Subject: Response to Comments
Sediment Investigation Results and Proposed Additional Sediment Sampling
Sims Group USA Corporation, Redwood City, California

On behalf of Sims Group USA Corporation (Sims), Terraphase Engineering Inc. (Terraphase) submitted the *Interim Sediment Investigation Results and Proposed Additional Sediment Sampling* report (dated August 31, 2016) to the United States Environmental Protection Agency (EPA). On October 26, 2016, the EPA provided comments on the report. This letter responds to EPA's comments.

FIGURE 17

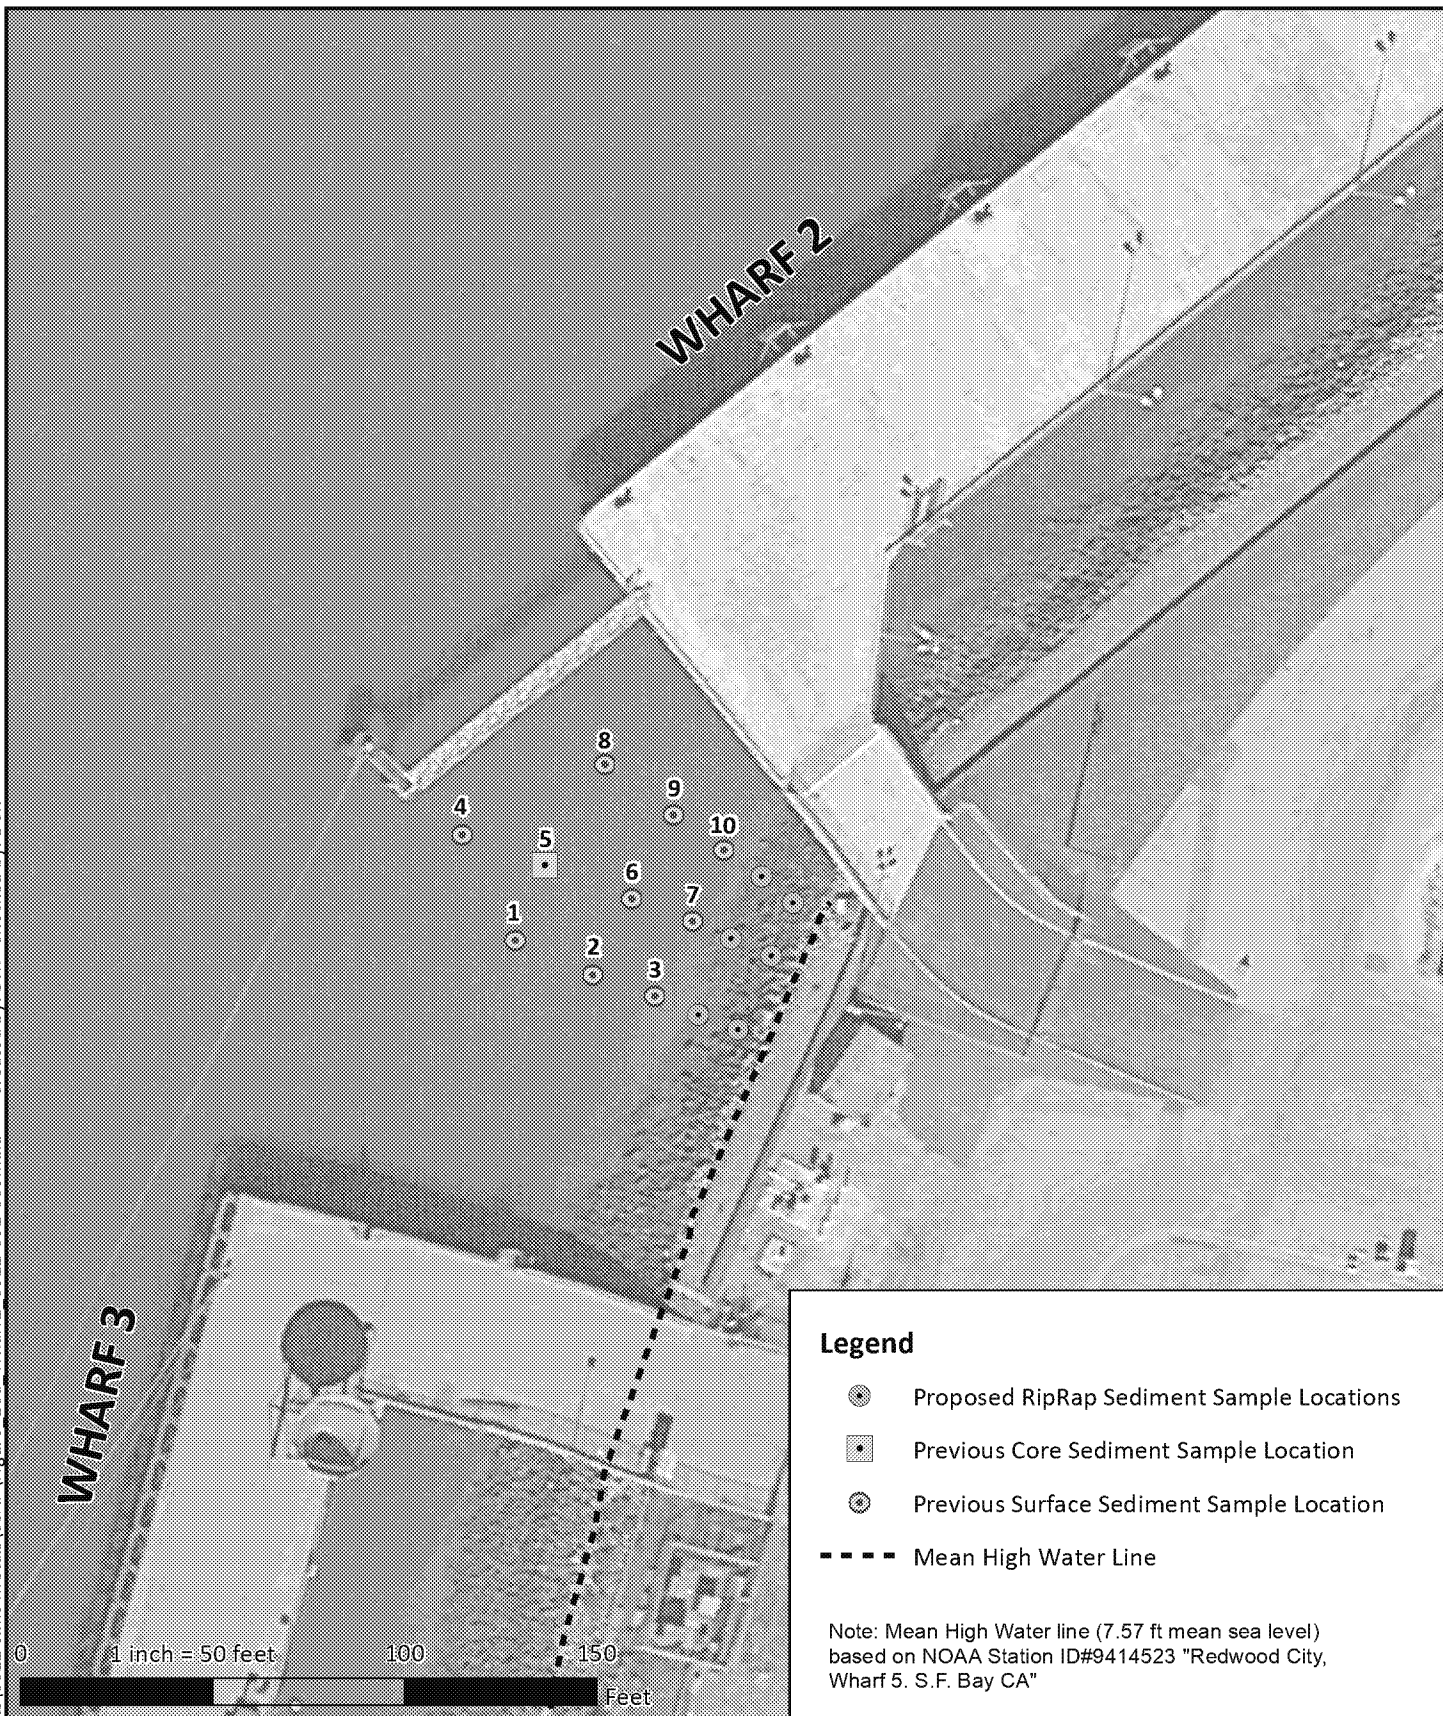
Add 8 Core Locations for lateral distribution: *The transect core locations proposed by Sims to the south of Wharf 3 (locations 7, 8, 9, 40) should also include core samples at locations 39 and 38. In addition, the transect core locations proposed by Sims to the north of Wharf 3 (locations 47, 48, 49, 50) should also include location 52. Lastly, in addition to the core samples for locations 5 and 41 proposed by Sims, EPA believes core samples should also be taken at locations 6, 4, 2, 43 and 44.*

Surface Samples: *Sims has proposed taking 5 more surface samples within the project area (3 locations approximately 25 feet south of locations 32, 35, and 38, and 2 locations north of locations 51 and 52). We agree with those 5 locations, but believe that Sims should also take at least one other surface sample south of location 19.*

The additional core sampling locations requested by the EPA will be added to the scope of work. A total of 18 sediment cores will be collected. The core sample identification numbers are summarized in Table 1. Figure 17 has been revised to indicate planned core sediment sample locations.

Figure 17 has been revised to indicate that a surface sediment sample will be collected at location 19 in addition to the previously proposed locations. A total of six surface ponar grab samples will be collected.

FIGURE 18a

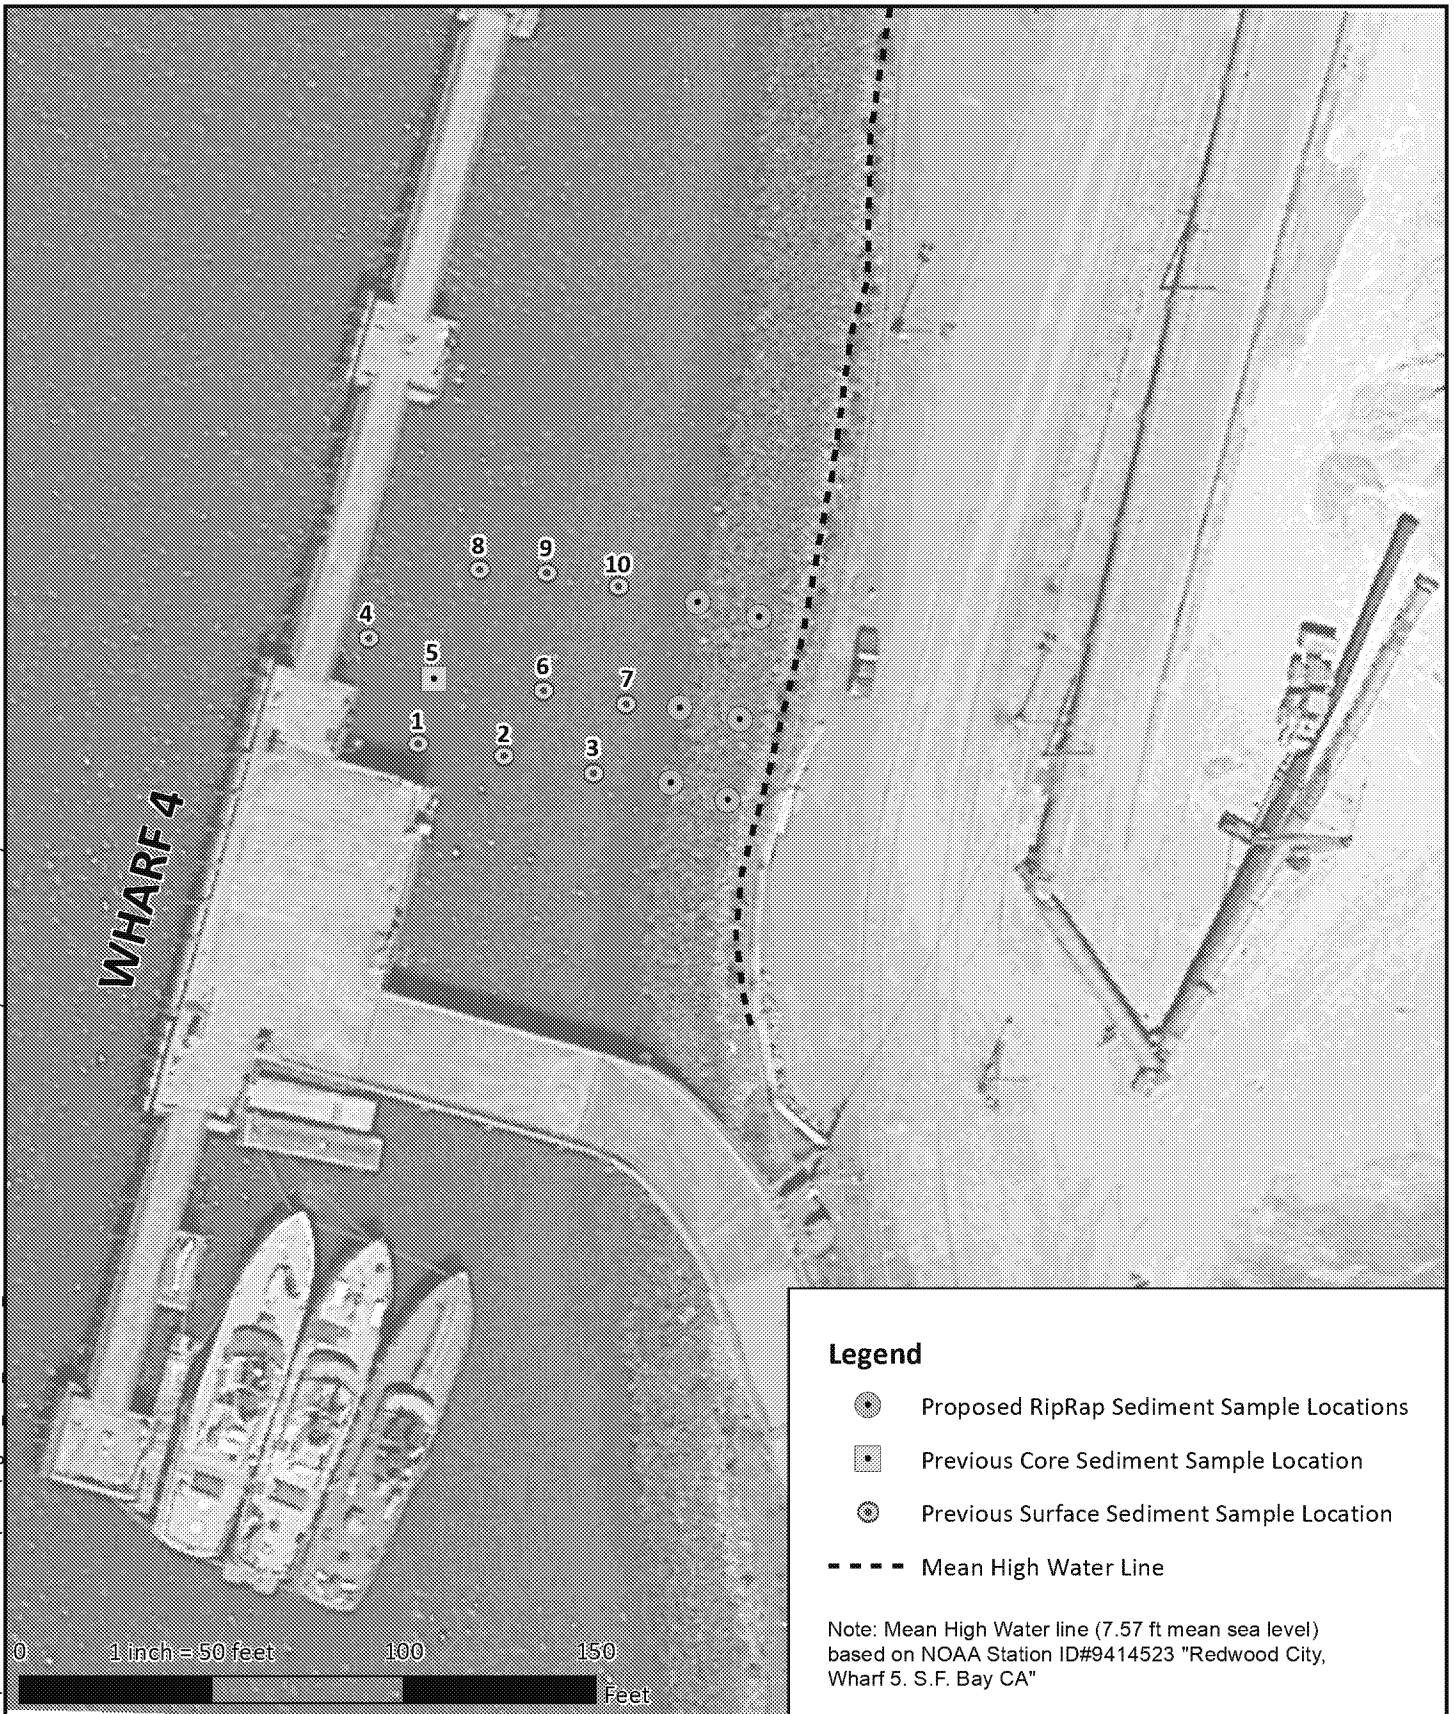
Surface Samples: *Sims has proposed taking 6 additional surface samples at each of the 3 background areas (Figures 18a, b, and c). In general, we agree with taking those samples, but for comparison, we believe they should be at elevations that are in line with the riprap surface sediments that were taken in the project area. Based on the aerial photos provided in its report, the locations Sims has proposed in the background areas seem closer to the mean high water line than the surface riprap samples within the project area. Please add a mean high water line to Figures 18a, 18b, and 18c and evaluate if the background sample locations need to be adjusted to match the elevation of similar grab samples in the project area.*

The surveyed MHW line has been added to all figures that depict the background sample locations from the prior phase of investigation, and the proposed additional locations (Figures 18a, 18b and 18c). The proposed background locations are all below the MHW line.
